PRODUCT/PROCESS CHANGE NOTICE (PCN)

PCN #: A1804-01 DATE: 18-Apr-2018 Product Affected: TSE2004GB2C0NCG TSE2004GB2C0NCG8 Date Effective: 18-Jul-2018	MEANS OF DISTINGUISHING CHANGED DEVICES: <input type="checkbox"/> Product Mark <input type="checkbox"/> Back Mark Assembly lot# prefix: <input type="checkbox"/> Date Code "TF" denote TFME, China <input checked="" type="checkbox"/> Other "HT" denote HTC, China
--	---

ATTACHMENT 1 - PCN # : A1804-01

PCN Type: Manufacturing Site - Alternate Assembly, Test & Backend Location

Table 1: Carrier Tape Comparisons

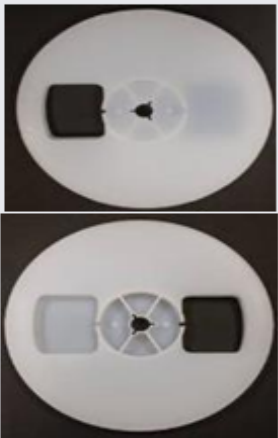
Carsem, Malaysia	TFME, China
Part Number	C-PAK BD0200x0300	ECA1941-PS-BLK-520
Ao	2.3+0.1mm	2.3+0.05mm
Bo	3.2+0.1mm	3.2+0.05mm
Ko	1.0+0.1mm	1.0+0.05mm
P	4.0+0.1mm	4.0+0.1mm
W	8.0+0.3mm	8.0+0.2/-0.1mm
Drawing	Refer Page 7	Refer Page 8
Snapshot

Table 2: Plastic Reel Comparisons

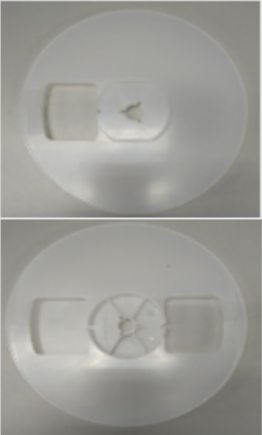
Carsem, Malaysia	TFME, China
Part Number	NEWTECH P9-065-000 White	E-PAK eRL0126-T08-A47-TRL
Reel Dia	7"	7"
Hub Dia	2"	2"
Drawing	Refer Page 9, 10	Refer Page 11
Snapshot

Table 3: Carrier Tape Comparisons

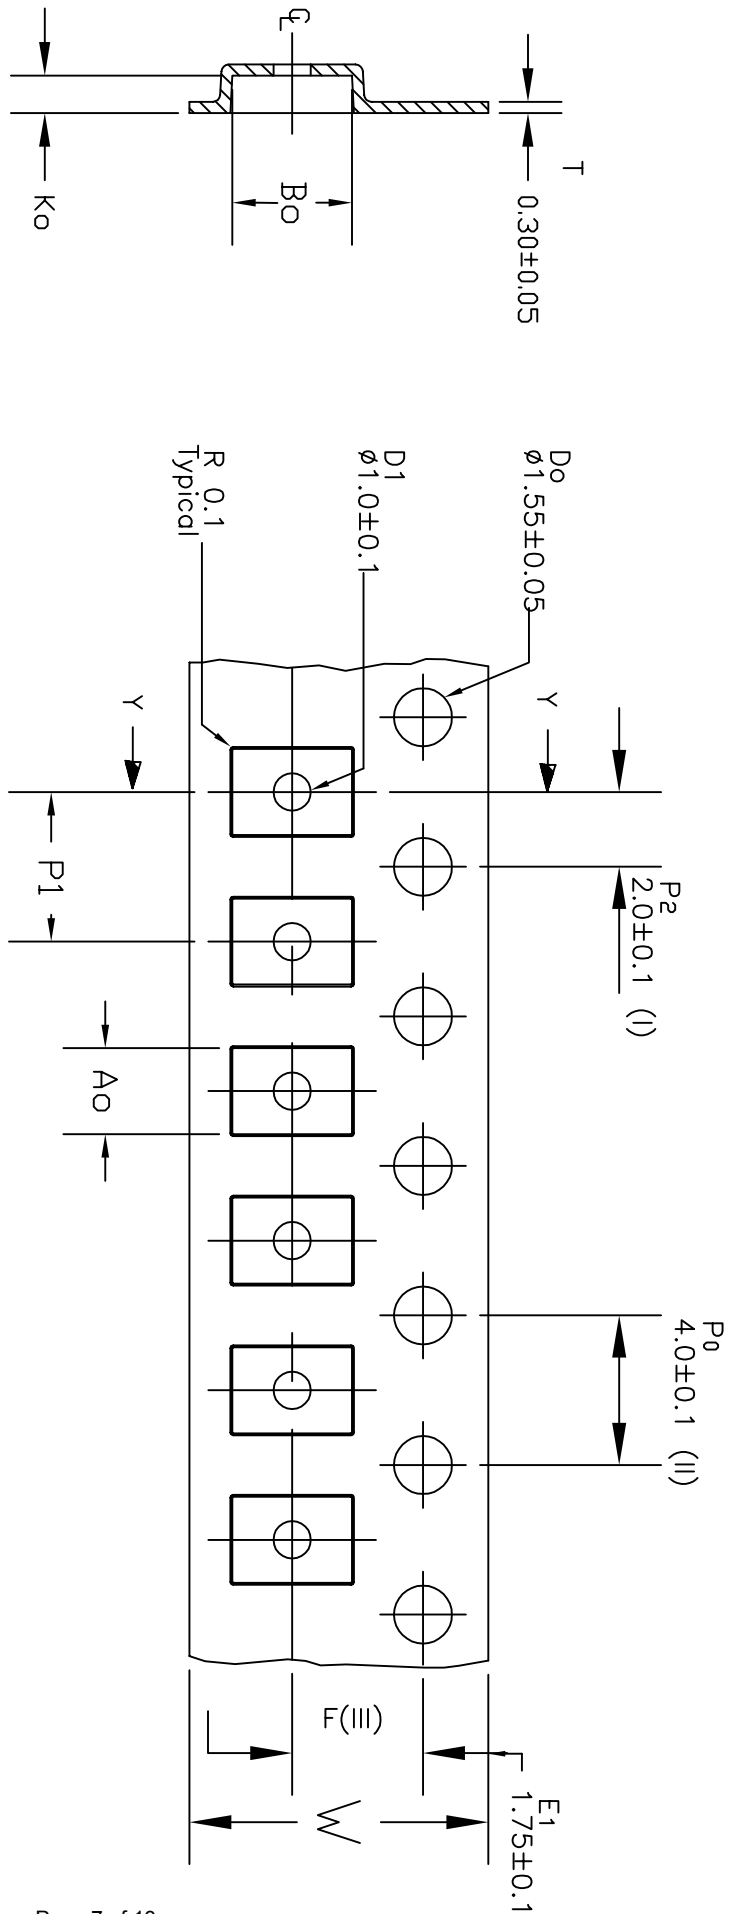
Carsem, Malaysia	HTC, China
Part Number	C-PAK BD0200x0300	ECA1941-PS-BLK-520
Ao	2.3+0.1mm	2.3+0.05mm
Bo	3.2+0.1mm	3.2+0.05mm
Ko	1.0+0.1mm	1.0+0.05mm
P	4.0+0.1mm	4.0+0.1mm
W	8.0+0.3mm	8.0+0.2/-0.1mm
Drawing	Refer Page 7	Refer Page 12
Snapshot

TITLE:		7" PLASTIC REEL FOR 8 MM	
STOCK NO.	DRAWING NO.	REV	SCALE
N/A	MSC-8402-A	00	N/A
DO NOT SCALE DRAWING	SHEET 1	OF 1

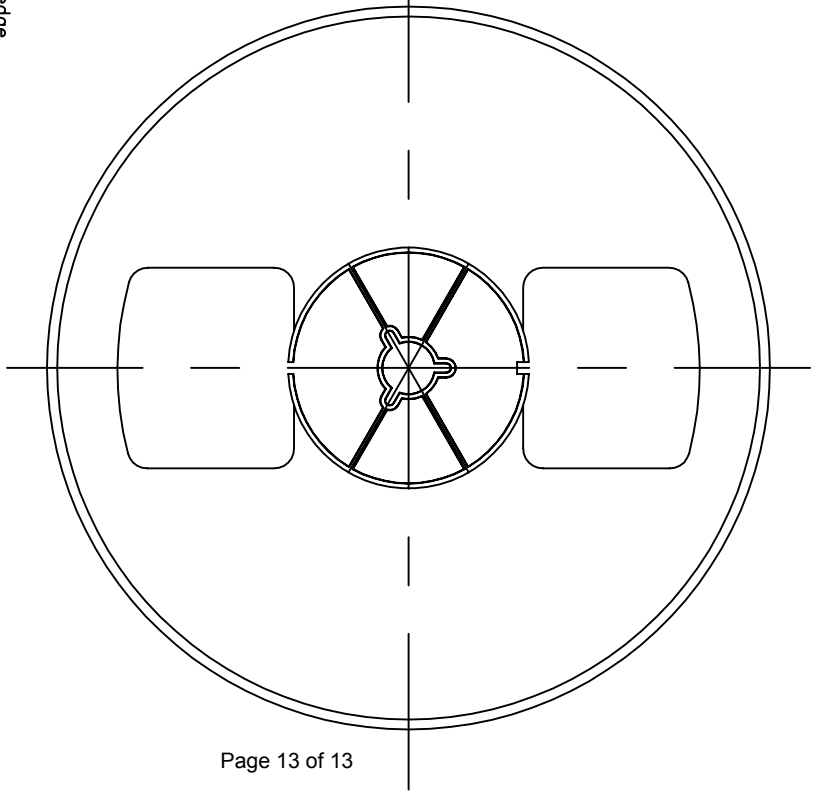
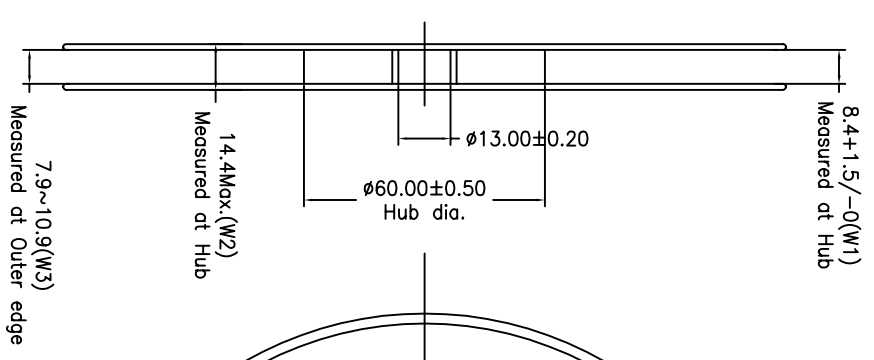
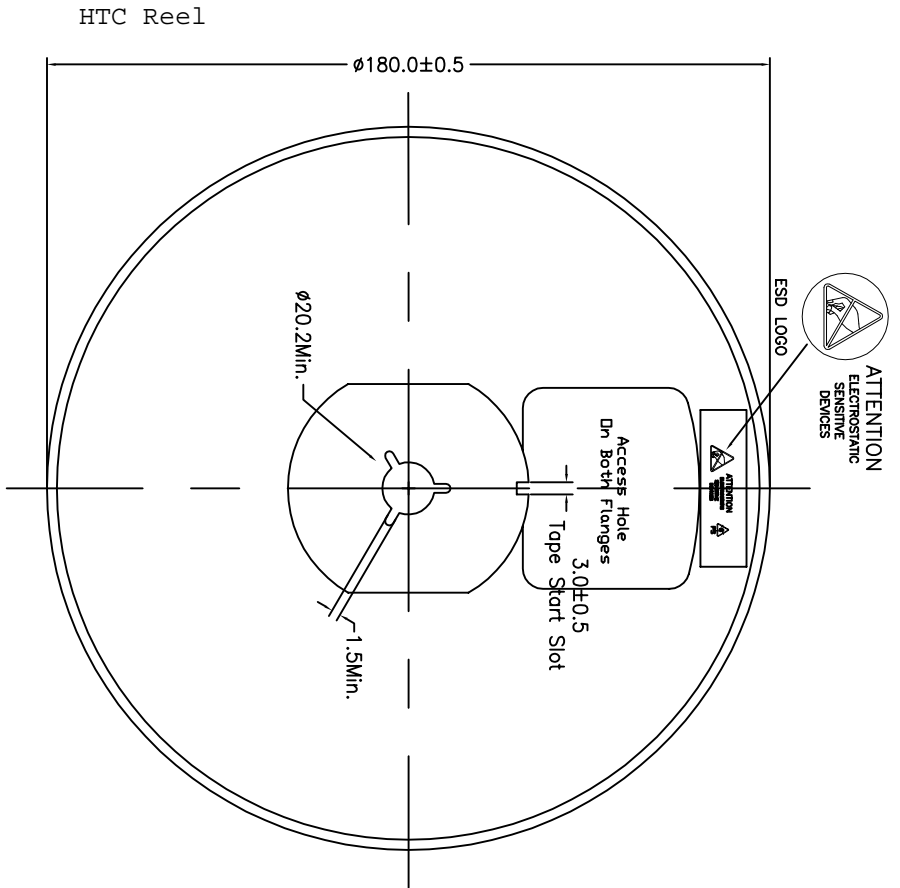
Carsem, Malaysia	HTC, China
Part Number	NEWTECH P9-065-000 White	E-PAK eRL0126-T08-A47-TRL
Reel Dia	7"	7"
Hub Dia	2"	2"
Drawing	Refer Page 9, 10	Refer Page 13
Snapshot
